PowerGrip® Kit K015432XS for Fiat and Lancia 1.6 petrol engines

GATES REFERENCE: PowerGrip Kit K015432XS

On OE(S) level the synchronous tensioner on these engines has changed already three times. Our kit has always reflected those changes in the course of the years. Since the latest evolution looks quite different to the previous ones, we want to give this overview.

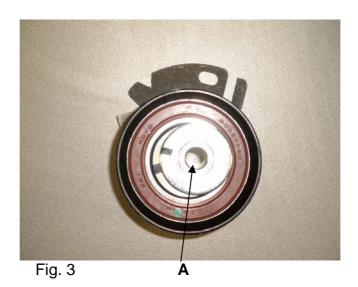
OE ref. 46792898 Fig. 1 tensioner in kit until 08/2004

Fig. 2 tensioner in kit from 09/2004 until 11/2005 OE ref. 46416489

Fig. 3 tensioner in kit as of 12/2005 OE ref. 71734799

The latest version that is now used on OE(S) level replaces the two previous parts.

It may be possible that the tensioner on the car is still an older model. There is no problem to install the latest version tensioner with the old stud and nut. Although the depth of the fixing hole (A) of the tensioner is deeper and the stud stays the same, there is still enough room on the stud to fix the nut properly, see Fig. 5 (B).
